Reasoned document on Final Draft Indian Railway Standard Specification for Fusion Welding of Rails By Alumino – Thermic Process Serial No. IRST-19- 2021

Fig.1

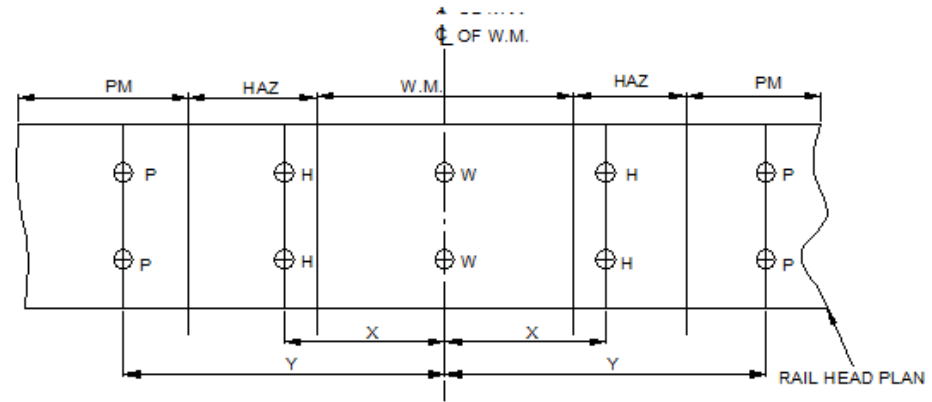
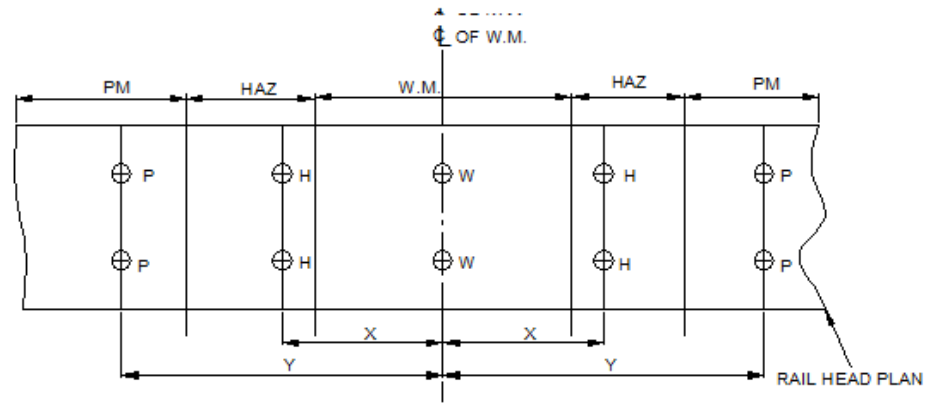
| M&C Dte RDSO comment | <p>Agreed.</p> <p>Rail used for AT welding shall be confirming to IRST-12-2009. Certificate regarding parent metal hardness shall be provided by AT weld portion manufacturer firms at the time of approval of AT welding technique and whenever required by RDSO.”</p> |

| Track Design Dte RDSO Remarks | After getting comments of M&C Dte, modified para has been added. | | | | | | | | | | | | |
|--|--|---------------------|--------------------|--------------------------------|---------------------------|--------------------------------|---------------------------|--------------------------------|------|------------|---------|---------|----------|
| Modified final draft specification after incorporating accepted comments. | <p>Hardness test Brinell hardness test shall be carried out at the welded zone, heat affected zones and parent metal of the rails in accordance with IS: 1500, "Method for Brinell Hardness test for steel". The test shall be done on the top surface of the head of the test weld with a ball of 10 mm Dia. and a test load of 3000 kg maintained for 10 secs. The hardness values of different rail chemistry on rail running surface of unaffected parent rail as per testing procedure and provisions specified in IRS/T-12-2009 are given in Table 1A for reference –</p> <p style="text-align: center;"><u>Table - 1A</u></p> <table border="1" data-bbox="779 555 1973 1046"> <thead> <tr> <th data-bbox="779 555 956 738">Type of rail</th> <th data-bbox="960 555 1093 738">72 UTS rail</th> <th data-bbox="1097 555 1229 738">90 UTS rail</th> <th data-bbox="1234 555 1440 738">R260 rail</th> <th data-bbox="1444 555 1695 738">1080 Head Hardened rail</th> <th data-bbox="1700 555 1973 738">1175 HT grade rail</th> </tr> </thead> <tbody> <tr> <td data-bbox="779 742 956 1046">Running Surface Hardness (BHN)</td> <td data-bbox="960 742 1093 1046">229*</td> <td data-bbox="1097 742 1229 1046">Min 260</td> <td data-bbox="1234 742 1440 1046">260-300</td> <td data-bbox="1444 742 1695 1046">340-390</td> <td data-bbox="1700 742 1973 1046">350 -390</td> </tr> </tbody> </table> <p style="text-align: center;">* For 72 UTS rail, average hardness (BHN) is 229</p> | Type of rail | 72 UTS rail | 90 UTS rail | R260 rail | 1080 Head Hardened rail | 1175 HT grade rail | Running Surface Hardness (BHN) | 229* | Min 260 | 260-300 | 340-390 | 350 -390 |
| Type of rail | 72 UTS rail | 90 UTS rail | R260 rail | 1080 Head Hardened rail | 1175 HT grade rail | | | | | | | | |
| Running Surface Hardness (BHN) | 229* | Min 260 | 260-300 | 340-390 | 350 -390 | | | | | | | | |

| | <p>R260 grade rail as specified above shall be considered.</p> <p>Similarly, for AT welding Joints of 60kg (90UTS) Vs 60kg/60E1 (1175 HT grade) rails and 60kg/60E1 (R260) Vs 60kg/60E1 (1175 HT grade) rails, with 25 mm Nominal gap, Hardness values corresponding to 60kg/60E1 (1175 HT grade) rail as specified above shall be considered.</p> <p>Rail used for AT welding shall be confirming to IRST-12-2009. Certificate regarding parent metal hardness shall be provided by AT weld portion manufacturer firms at the time of approval of AT welding technique and whenever required by RDSO.</p> |
